Rules and Regulations for the Classification of Naval Ships, January 2009

Notice No. 2

Issue date: August 2009

This Notice contains amendments within the following Sections of the *Rules and Regulations for the Classification of Naval Ships, January 2009.* The amendments are effective on the dates shown:

Table 2.3.1 Thickness of end brackets

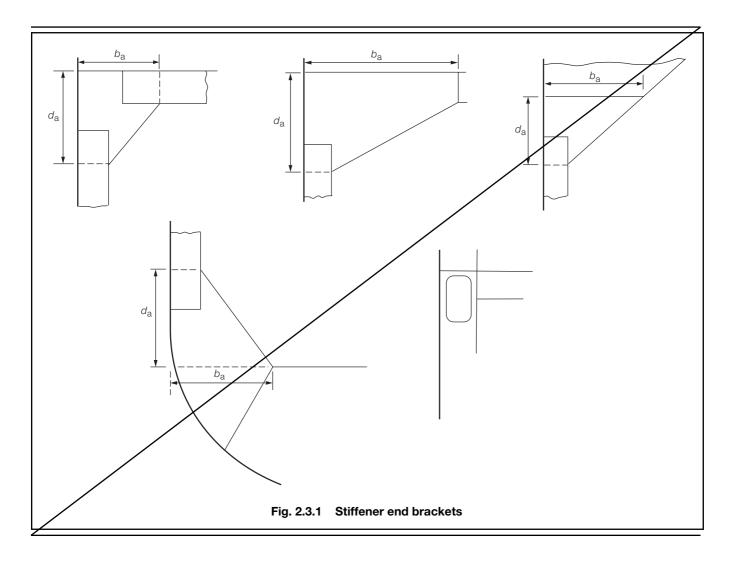
3.2.7 The free edge of the bracket is to be stiffened where any of the following apply:

- (a) The section modulus, Z, exceeds 2000 cm<sup>3</sup>.
- (b) The length of free edge exceeds 50 times the bracket thickness.
- (c) The bracket is fitted at the lower end of main transverse side framing.

3.2.14 The thickness of the bracket is to be not less than as required by Table 2.3.1.

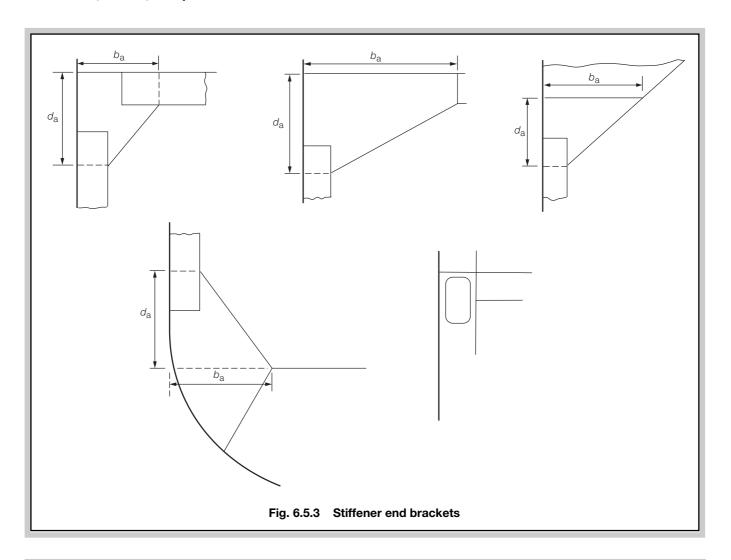
- 5.4.4 Typical arrangements of stiffener end brackets are shown diagrammatically in Fig. 6.5.3.
- 5.4.5 The lengths,  $d_a$  and  $b_a$ , of the arms are to be measured from the plating to the toe of the bracket and are to be such that:

- The design of end connections and their supporting structure is to be such as to provide adequate resistance to rotation and displacement of the joint.
- The thickness of the bracket is to be not less than 5.4.14 as required by Table 6.5.2.
